Re: St. Lucie Plant Unit 2
Docket No. 50-389
Renewed Facility Operating License No. NPF-16

Response to NRC Request for Additional Information (RAI) Regarding Extended
Power Uprate License Amendment Request

**Response to NRC Nuclear Performance and Code Branch
Request for Additional Information**

SNPB-16

The variables listed in Tables 2 and 3 are plotted as functions of time for the 0.6 DEG/PD break, the limiting LBLOCA, in Figures 19 through 38.

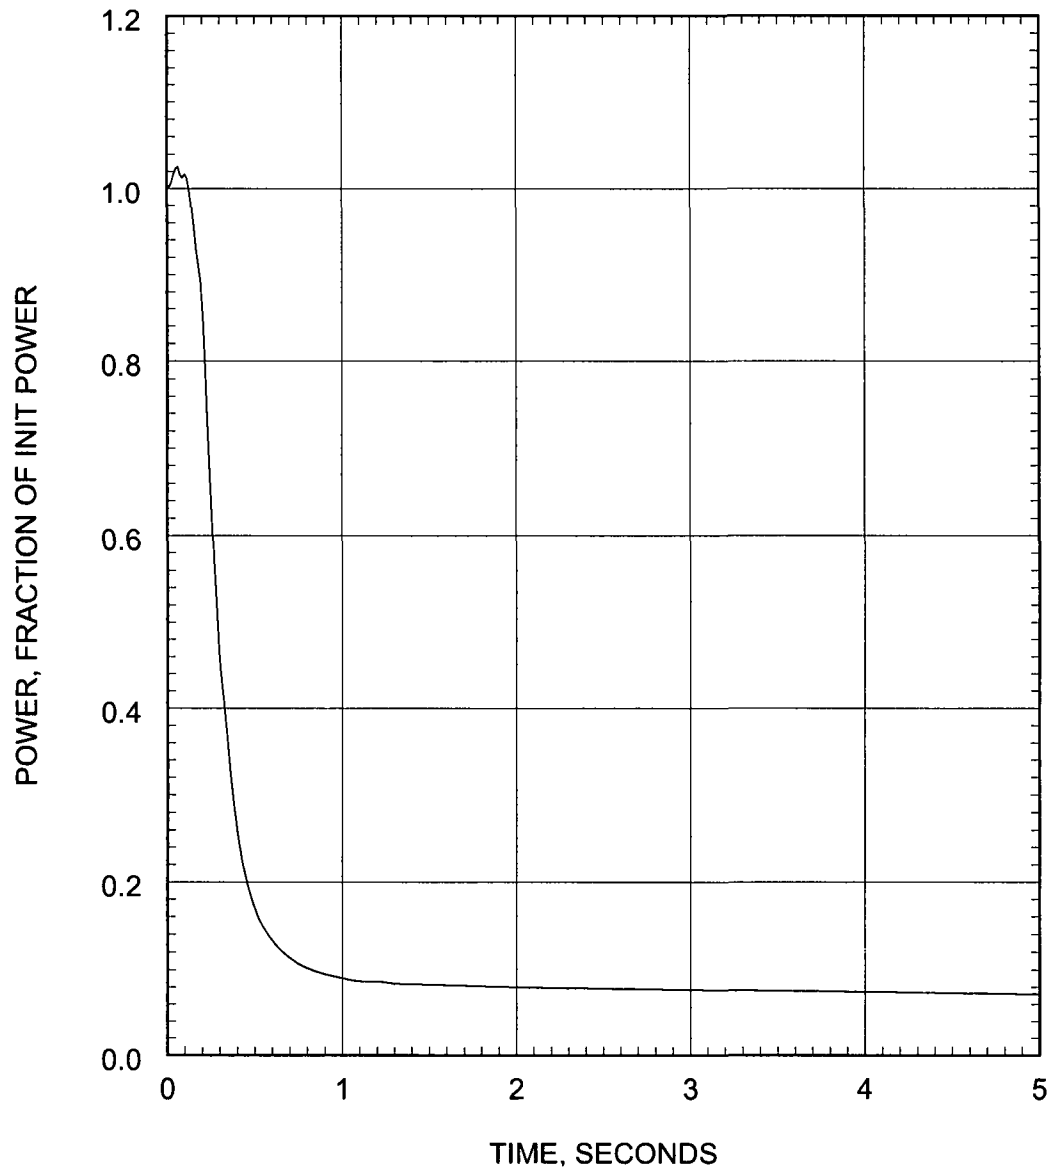
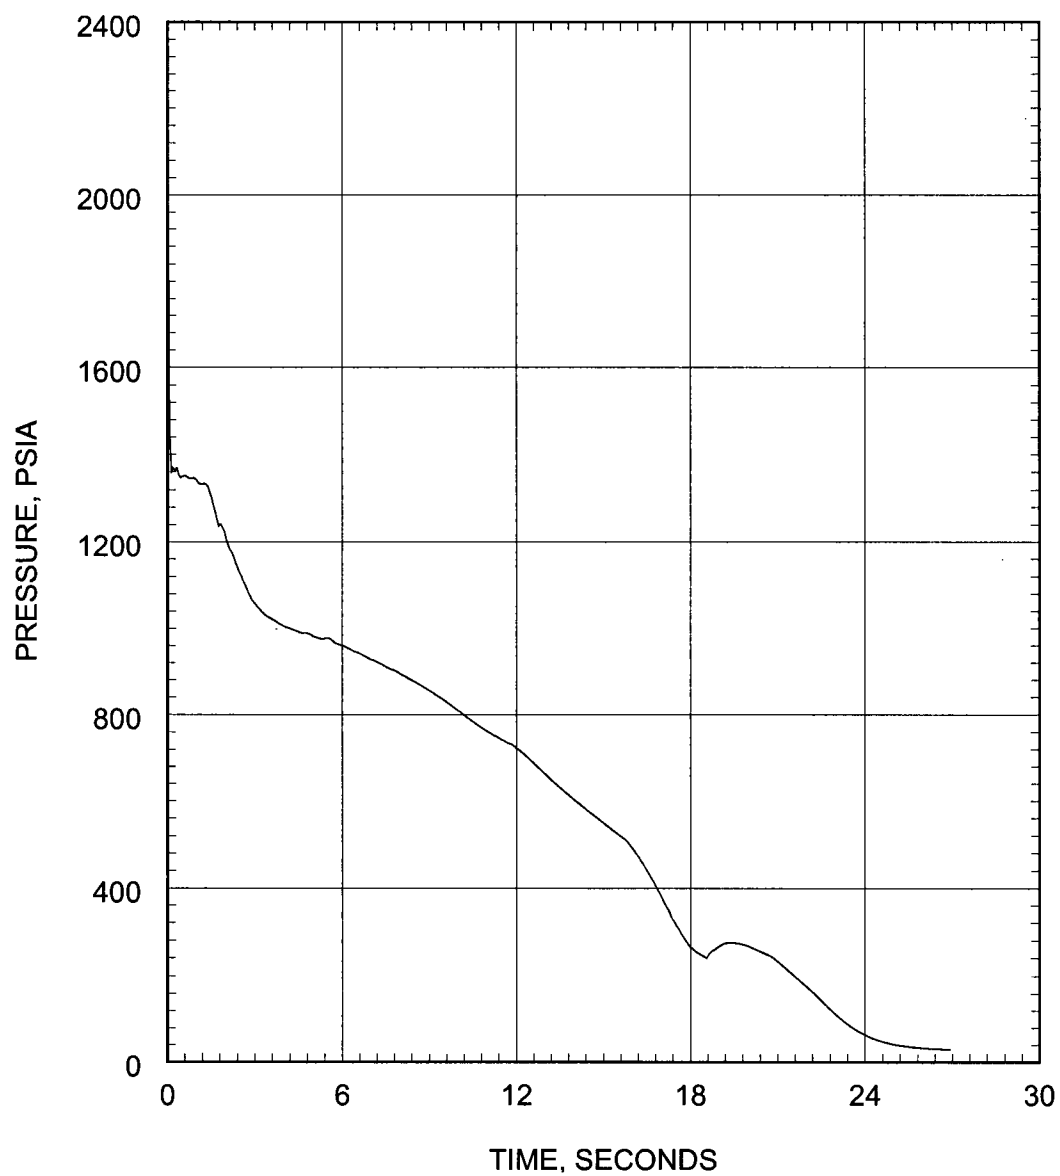
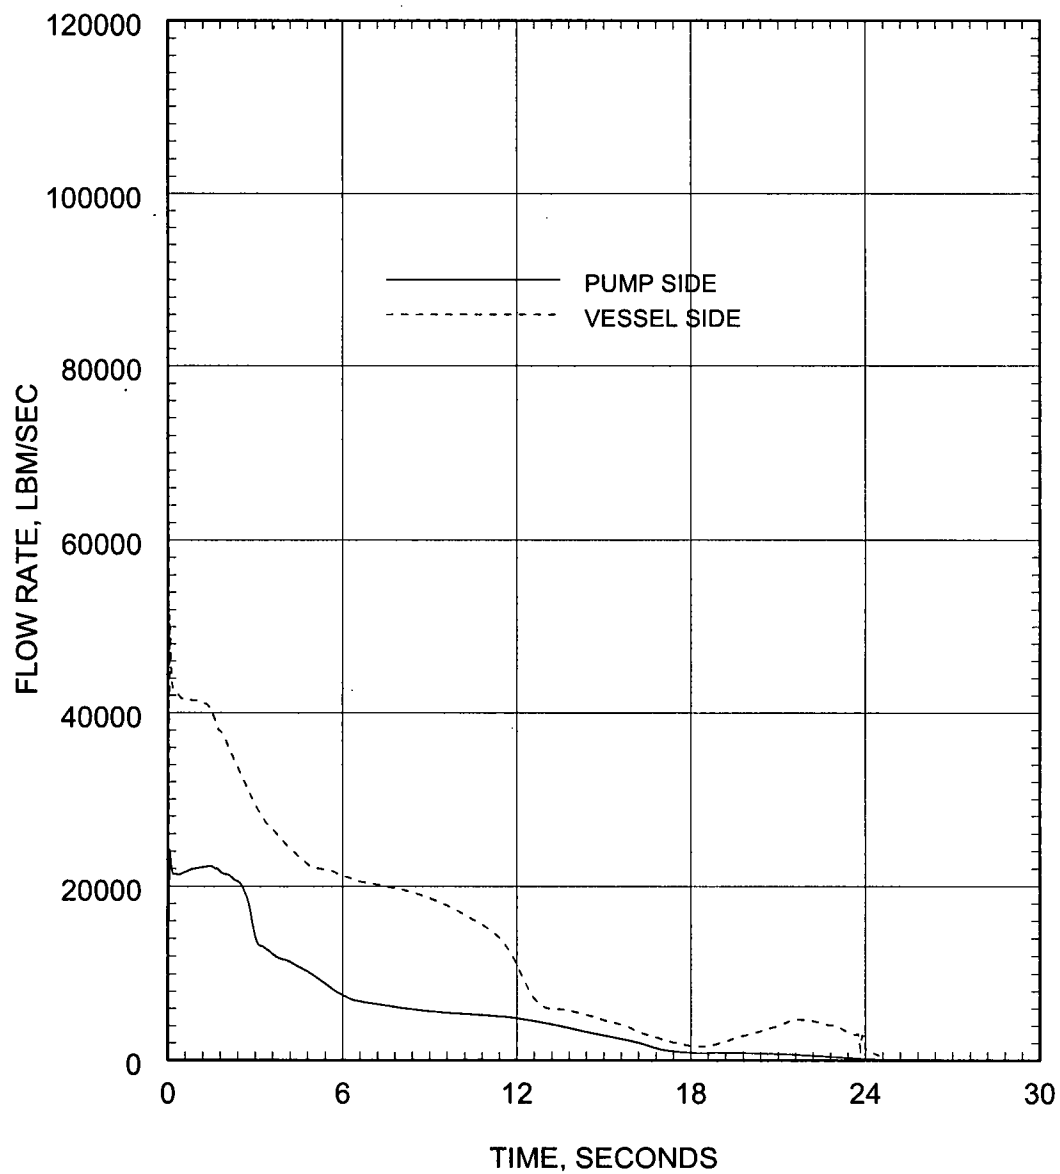
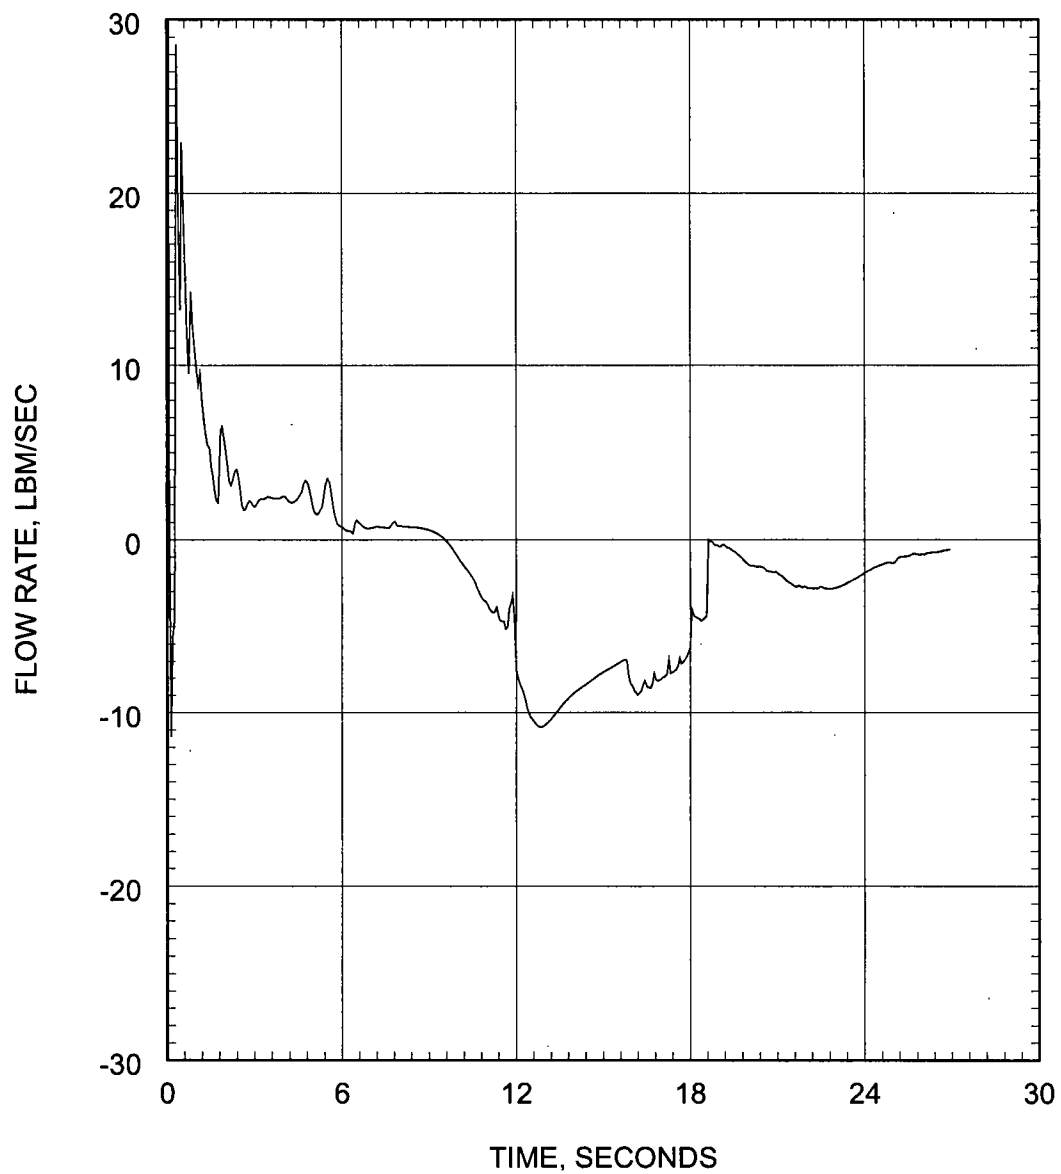
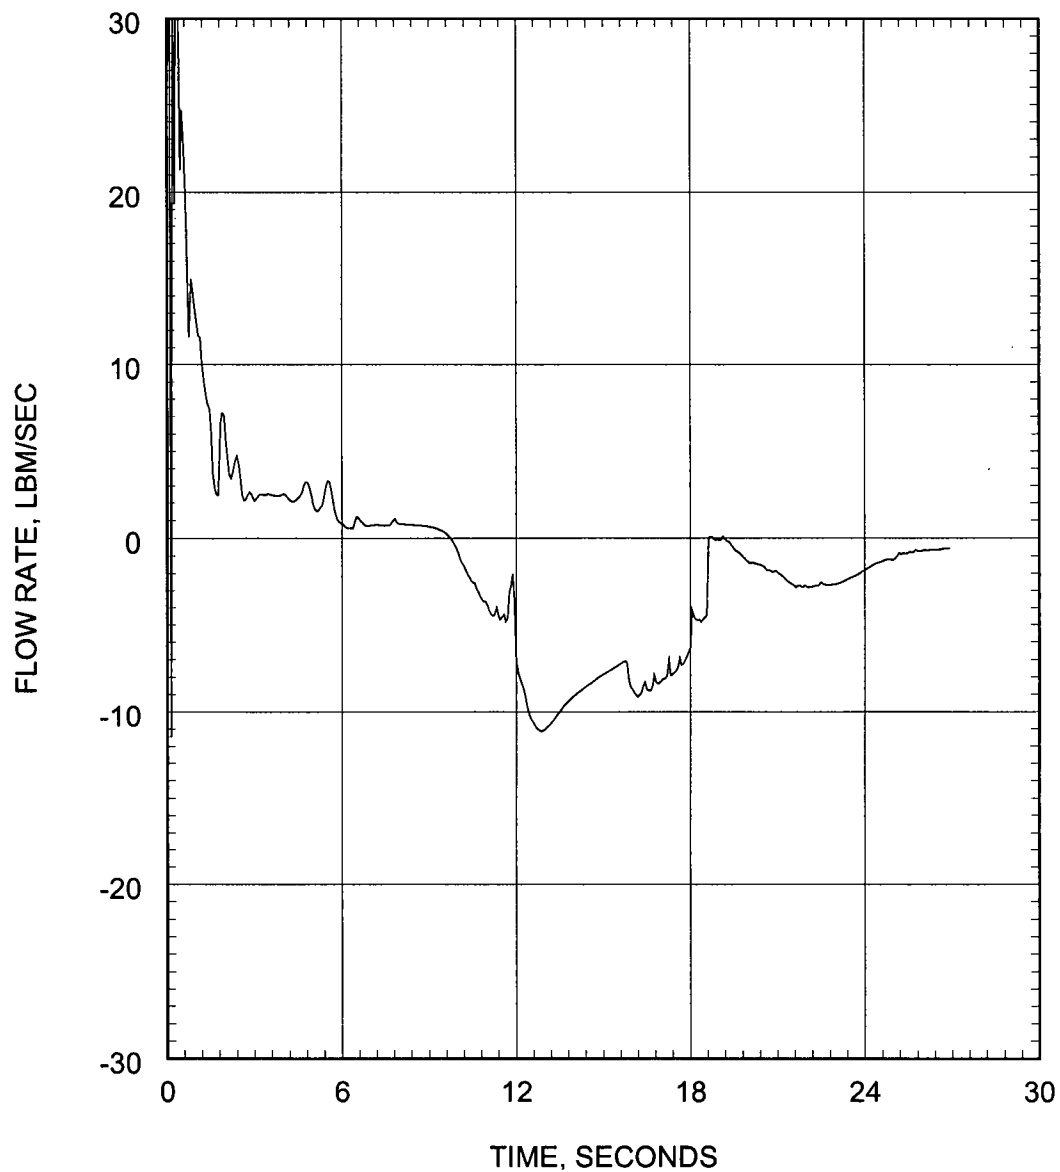
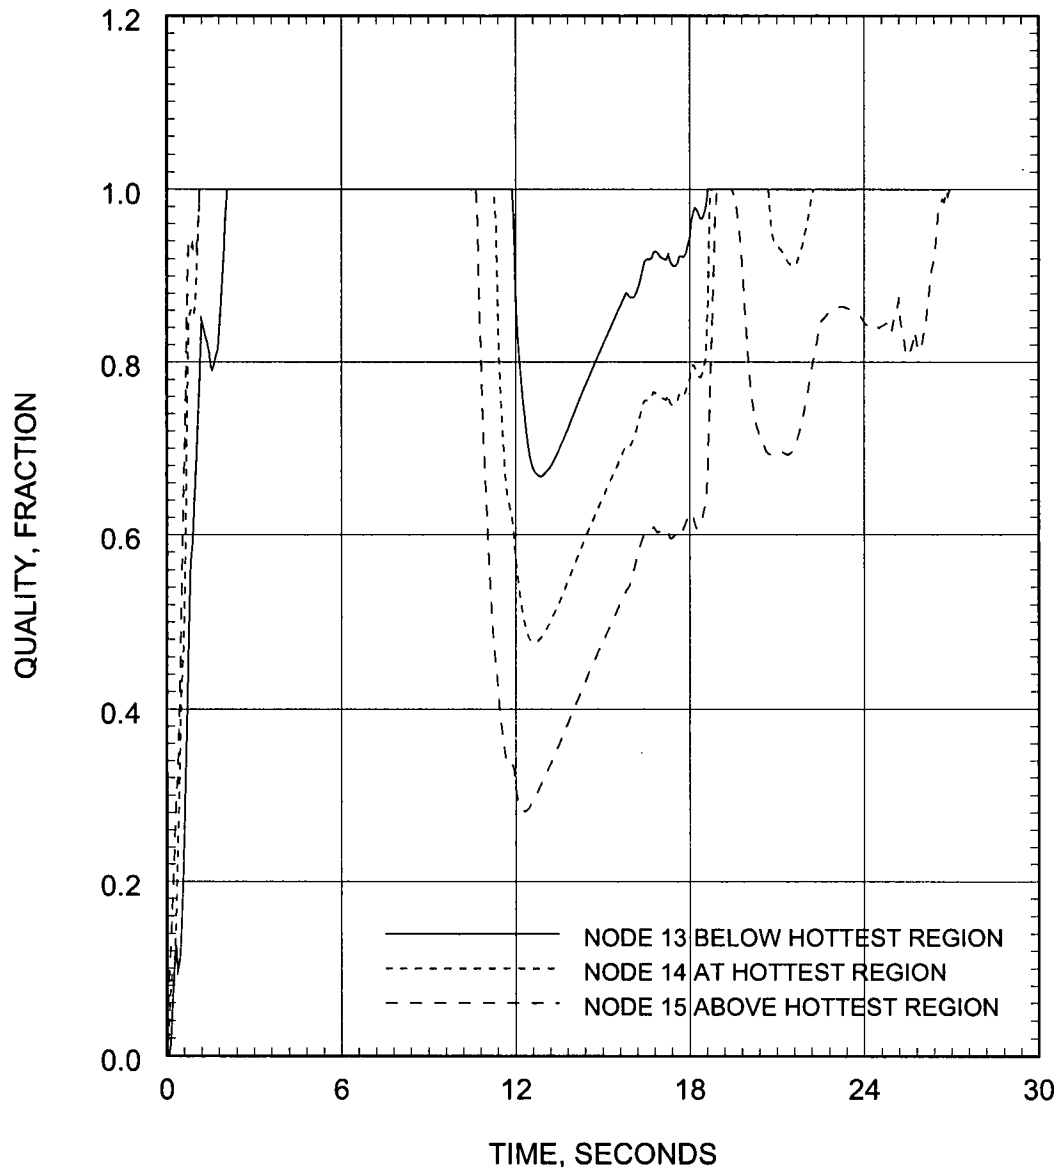
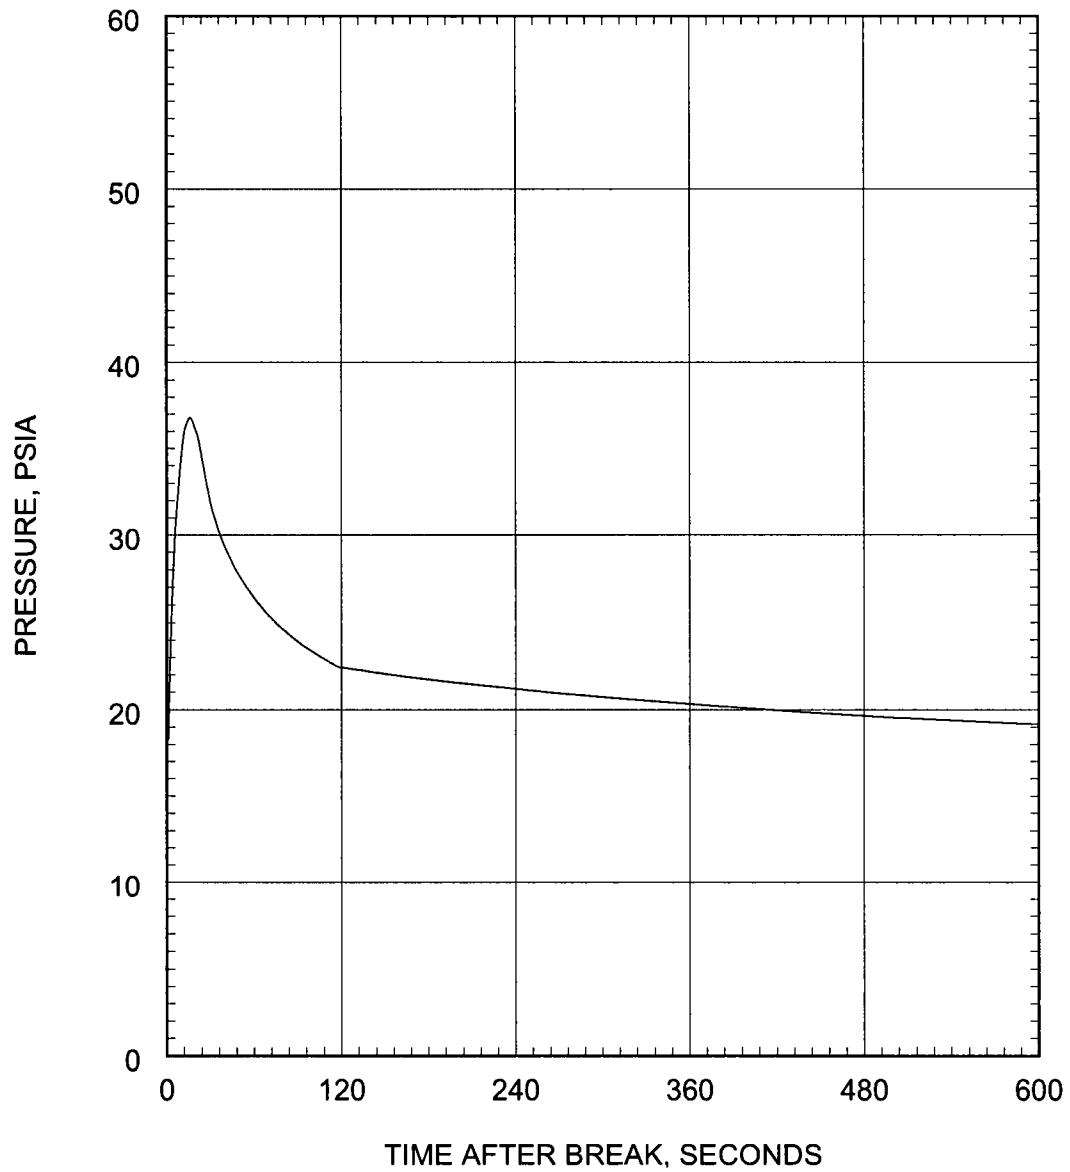
Please provide the results of the seismic LOCA loads analysis for the limiting break. Identify the maximum hot channel deformation/flow area reduction, the maximum hot bundle flow area reduction, the peak linear heat rate for the hottest rod in the assembly undergoing maximum deformation. Also, provide the linear heat rate for the bundle containing the rod with the max deformation. The analysis should provide the plots typical of the limiting large break LOCA analysis given in a chapter 15 analysis.

The seismic LOCA loads analysis confirms that 10CFR50.46 criteria related to peak cladding temperature and maximum cladding local oxidation criteria are satisfied for LOCA analysis of hot rods in peripheral fuel assemblies with maximum credible grid deformation, i.e., fully collapsed grids. The LOCA analysis is performed with the 1999 EM and conforms to guidelines for the evaluation of fuel assembly structural response to externally applied forces specified in NUREG 0800, SRP 4.2, Appendix A, Section IV, related to requirements from 10CFR50.46 ECCS Performance design basis criteria and use of maximum credible grid deformation. The maximum allowable LHR in peripheral distorted assemblies is determined to be 95% relative to the maximum LHR in the core.
